RE: 2014 Abandonment of Water Monitoring Wells, Canyon Fuel Company, LLC, Skyline Mine,
C/007/005

Title: 2014 Well Abandonment

Location of Hydrologic Monitoring Stations

SCALE: 1" = 2000'
DATE: 04-04-01
DWG. NO.: 2.3.6-1
DR. BY: JLP

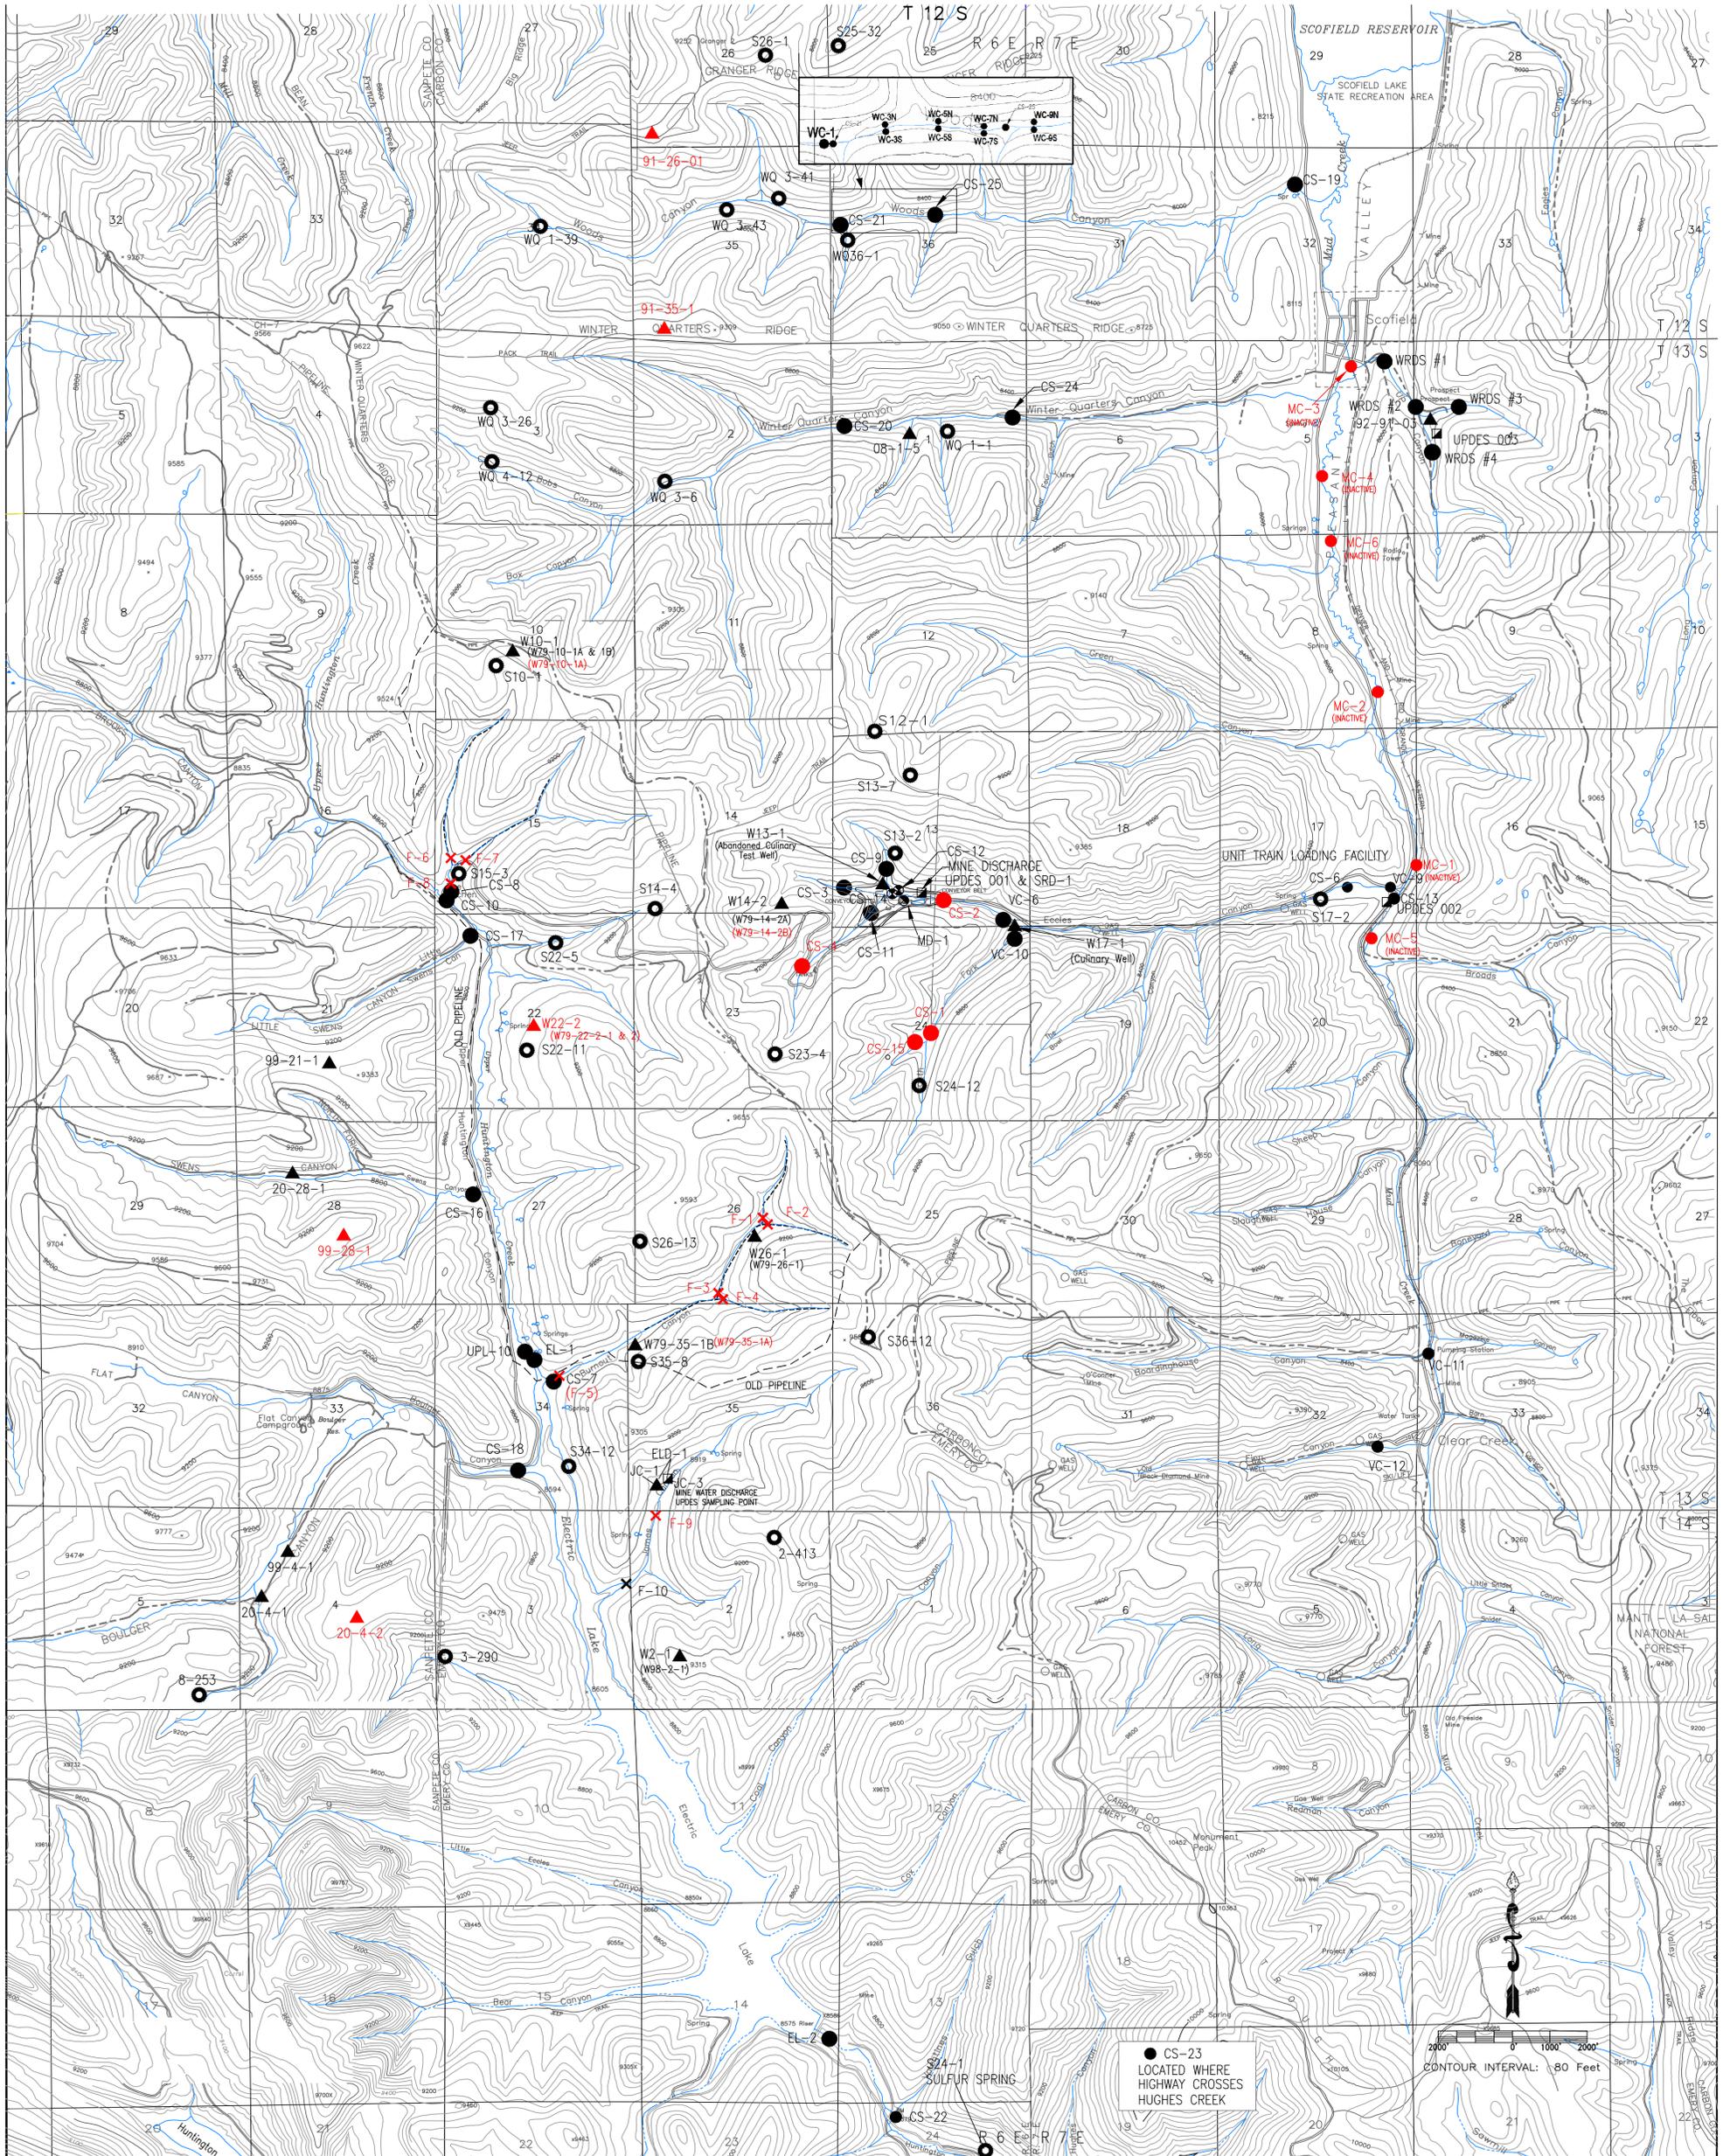
| DATE | No. | REVISIONS | BY | DATE | No. | REVISIONS | BY |
|----------|-----|--|-------|---------|-----|--|---------|
| 11/19/04 | 7 | | CH | SEPT 14 | 16 | Discontinued Wells 91-26-1, 91-35-1, 79-35-1A | GAG/GAG |
